7. Nakada Subdivision Alexson Replat

KPB File 2023-126

**ITEM #7 - PRELIMINARY PLAT
Nakada Subdivision Alexson Replat**

KPB File No.	2023-126
Plat Committee Meeting:	December 11, 2023
Applicant / Owner:	Peter & Marie Alexson of Homer Alaska
Surveyor:	Stephen Smith / Geovera LLC
General Location:	Heather Street in Kachemak APC

NAKADA SUBDIVISION ALEXSON REPLAT

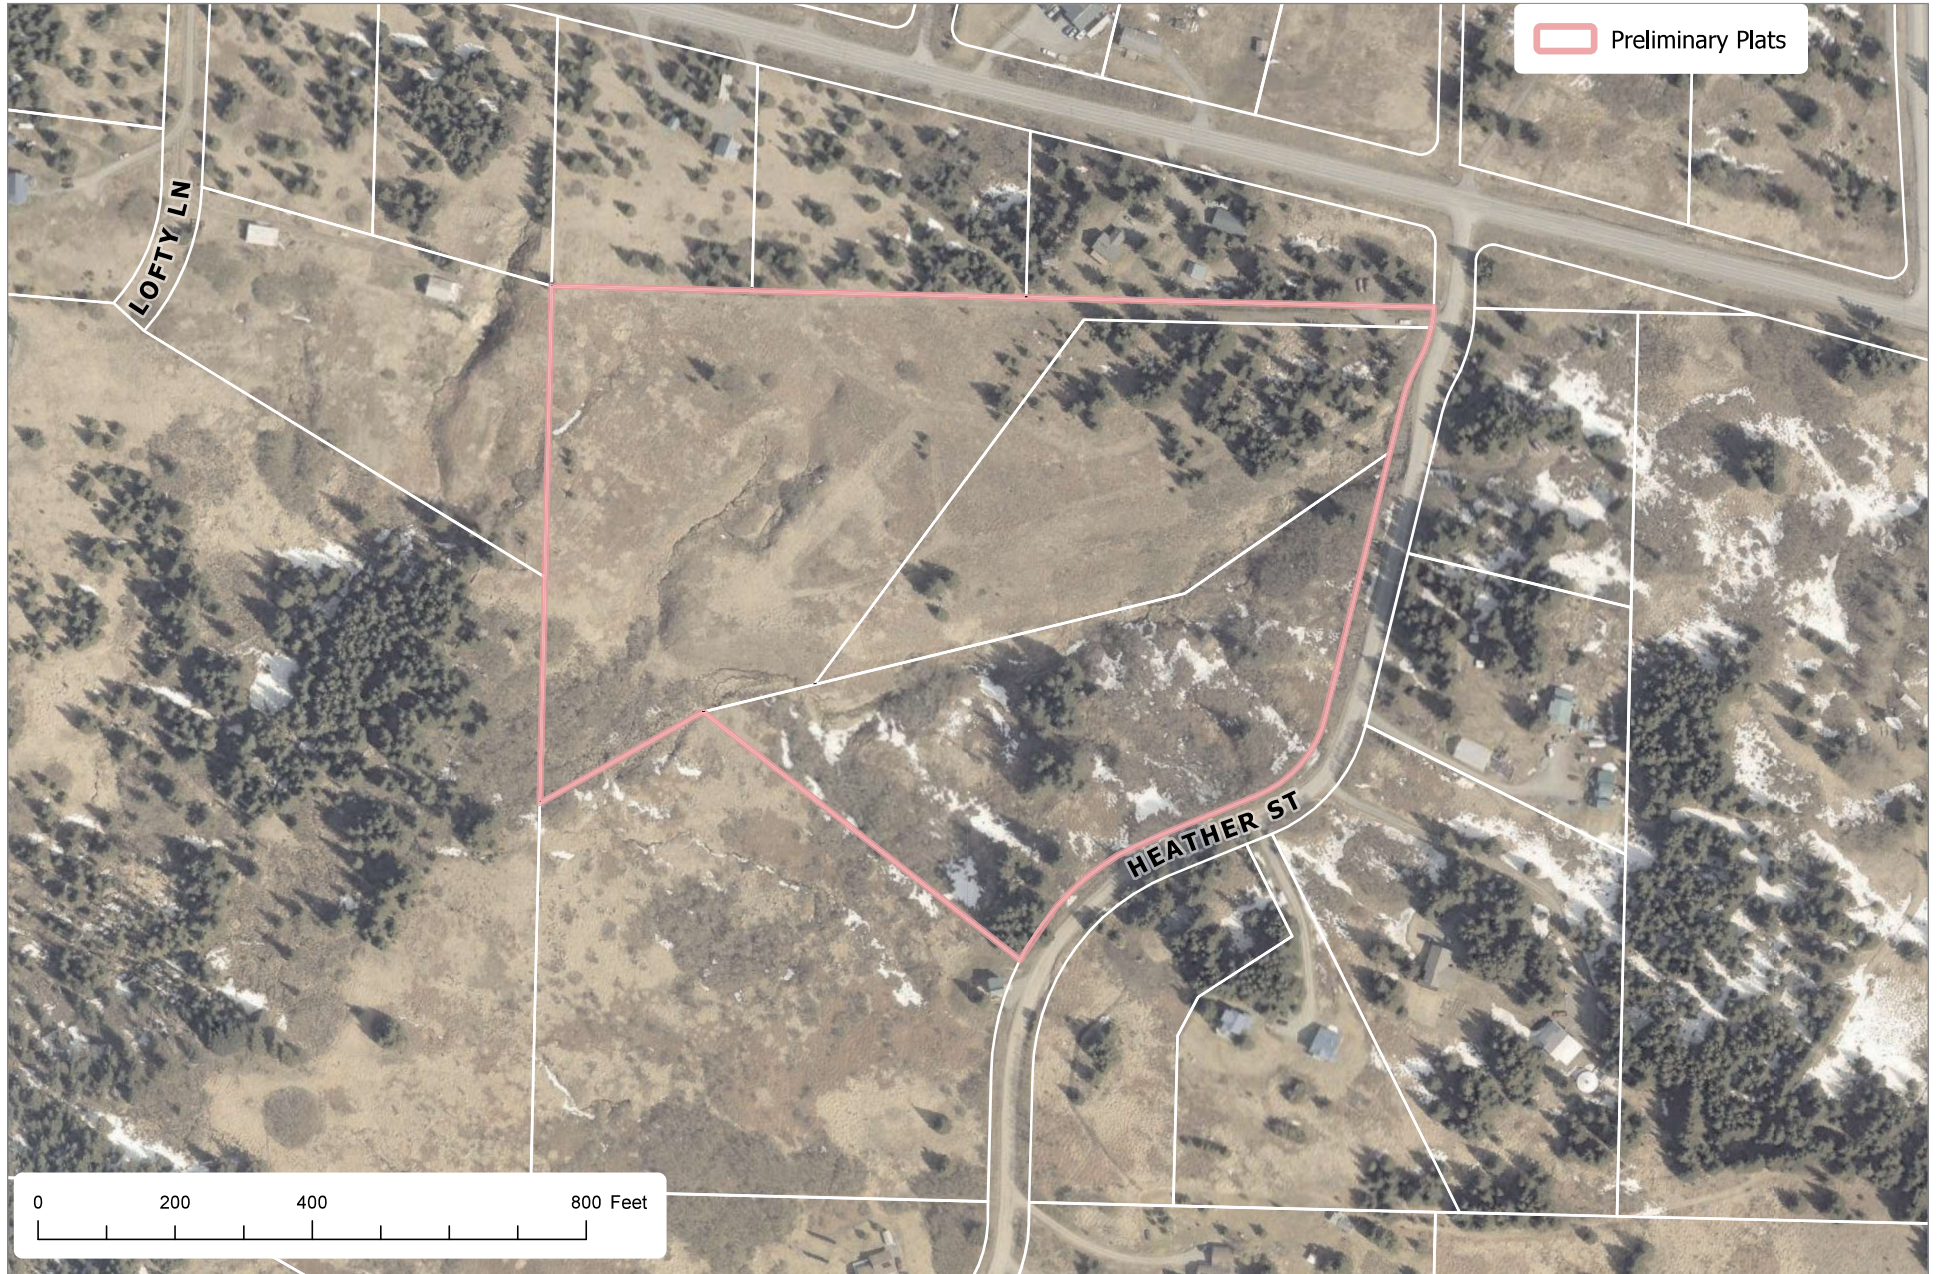
No new dedication is being proposed and a section line easement does not affect the property. There appears to be a section line easement to the northeast going north up Heather Street from the plat boundary and across Diamond Ridge Road, this easement should be confirmed and shown on the drawing.

Areas with slopes greater than 20 percent are shown on the plat. These should be changed to top of slope and toe of slope for the final and shading removed.

There are wetlands shown on the plat and should remain shown on the final.

There is a private ingress-egress easement listed in plat note #6 at document HM 2004-005555-0 that the location should be shown on the final.

Add 2023-126 to KPB No.

Add 'aka Pete' to the owner's name as it is being used in the Certificate of Ownership and Dedication.

Add the street name and ROW to Diamond Ridge Road.

Add the section line easement above the section to the east unless it is found to be vacated also.

Label ROW of Heather Street above section line.

Label the rivers and creeks on the map

Show and label Heather Street

The parcel northeast of the subdivision needs labeled with lot and plat label.

Curve and line table needs a note as to if they are listing recorded or measured data and then opposing data given.

- The borough will not enforce private covenants, easements, or deed restrictions per KPB 20.60.170.

Add the date of December 11, 2023 to the Plat Approval
